# Access Compliance Report

## Public Rights-of-Way

### (Curb Ramps)

Intersection ID: 12830	Main Street: CARYA_POND_LN	Cross Street: HICKORY_GROVE_RD	Location: W
ADA ID: 39B56BEF760B	Ramp Type: Para	Initial Pass/Fail: Fail	Overall Compliance: No
			Severity Score: 13.75

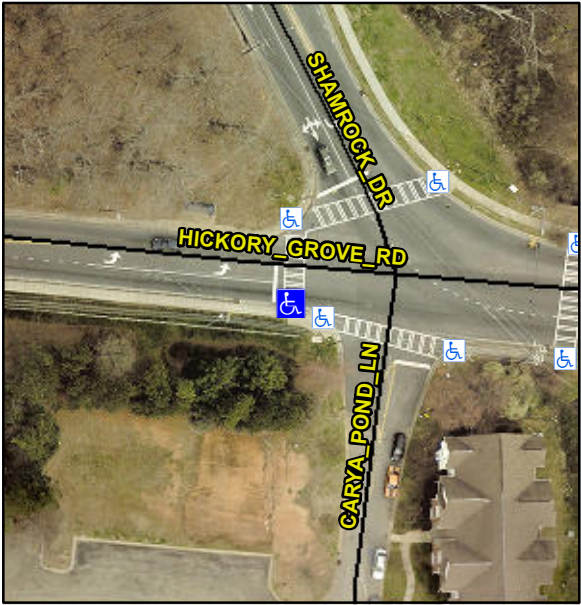
Codes/Mitigation Info/Possible Solution			Field Measurements/Component Compliance		
	Possible Solutions:		<b>Compliance</b>	<b>Description</b>	<b>Data</b>
	Remove & Replace Entire Ramp.		N/A	Ramp Length LT (in)	69.5
			Yes	Ramp Width LT (in)	59.5
			Yes	Ramp Slope LT (%)	5.9
			No	Ramp XSlope LT (%)	2.4
			N/A	Landing Length (in)	N/A
			N/A	Landing Width (in)	N/A
			N/A	Landing Slope (%)	N/A
			N/A	Landing X Slope (%)	N/A
			N/A	Landing Curb? (Y/N)	N/A
<p>Surveyor Notes:</p> <p>N/A</p> <p>PROW/ADA:</p> <p>R304.5.3, R304.3.2</p>			N/A	Shared Landing?	N/A
			N/A	Gutter Ponding?	N/A
			N/A	Gutter Lip Ht (in)	N/A
			N/A	Painted X Walk1?	No
				X Walk 1 Direction	To N
			N/A	X Walk 1 Width (in)	N/A
				X Walk 1 Slope (%)	4.2
				X Walk 1 X Slope (%)	2.2
			N/A	Ramp inside XWalk1?	N/A
				Road Slope (%)	N/A
<p>Street 1 Name</p> <p>Stop Condition-Street 1</p> <p>Street 2 Name</p> <p>Stop Condition-Street 2</p>			N/A	Road X Slope (%)	N/A

N/A	Any Obstructions?	N/A
				Obstruction Type	
<p>Total Cost:</p> <p>\$ 1600.00</p>			N/A		N/A
			Yes	Surface Condition? (G/P)	Good
			N/A	Curb Slope (%)	12.8
